**[Docket No. FAA-2010-1101; Directorate Identifier 2009-CE-013-AD; Amendment 39-16690; AD 2011-10-09]**

**Airworthiness Directives; Cessna Aircraft Company Models 150, 152, 170, 172, 175, 177, 180, 182, 185, 188, 190, 195, 206, 207, 210, T303, 336, and 337 Airplanes**

**ACTION:** Final rule.

Figure 1. Diameter of seat pin locking engagement hole

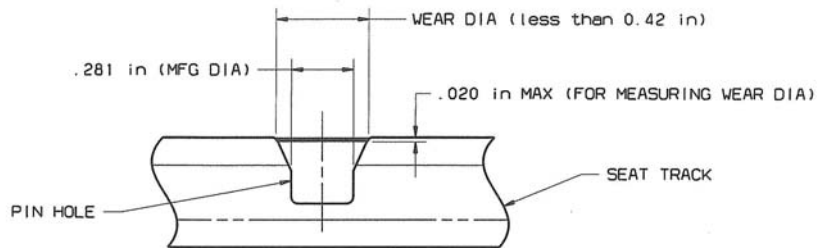
Dave McFarlane requested we add a maximum allowable incremental 0.07-inch radius dimension to figure 1 at the outside diameter dimensions for clarification.

We disagree with this comment. The measurement dimensions in figure 1 adequately address the measurements necessary for this AD. Additional measurements will not provide any additional benefit.

**Figure 4. Closeup of seat roller housing and tang gap width**

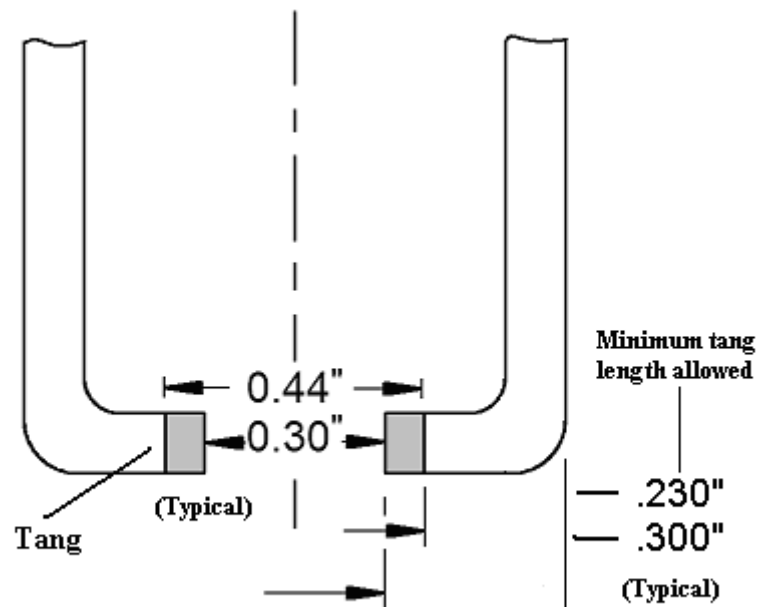
Brian A. Andrus, Jim Currie, and Jerry Unruh requested we change the tang measurement to the outside of the seat roller housing and change the description of the tang measurement. This change would make it easier for the inspector to take the measurement and to better understand what is being measured.

We agree with this comment. We agree that measuring the tang length inside of the roller housing is difficult because of the presence of the rollers inside of the roller housing.

We have changed the callouts in figure 4 to measure the tang length from outside of the roller housing instead of from inside of the roller housing. We have also changed the description of the tang measurement in figure 4 to more accurately describe the measurement.
